PHASE A & B OF 300 EAST MAIN CONDITIONAL USE PERMIT

Response to Advisory Board Comments

300 EAST MAIN STREET

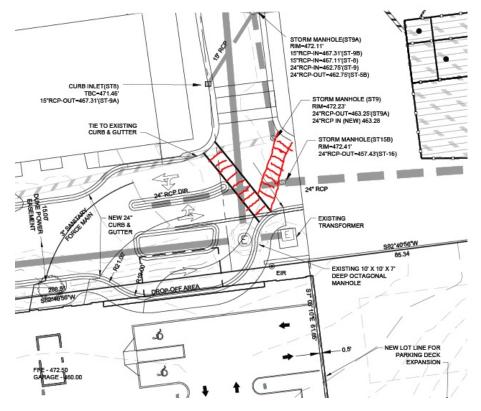
7. Thank you for redesigning the crosswalk in front of the hotel entryway. It is better than it was previously, but please consider making it a high visibility crosswalk instead of just two lines. Additionally, the TAB would like to see another crosswalk running diagonally from the northeast corner of the hotel/parking deck 'intersection' to the base of the existing crosswalk so pedestrians coming along that side of the street are not stranded (see rendition below).

The plans now show a high-visibility crosswalk. The second crosswalk shown in the TAB drawing is not included because with the vehicle traffic entering and exiting the parking deck it would not be a suitable path for pedestrians. Pedestrians approaching the Hilton Garden Inn from that side of the driveway can cross at the existing bricked crosswalk shown just north of this area.
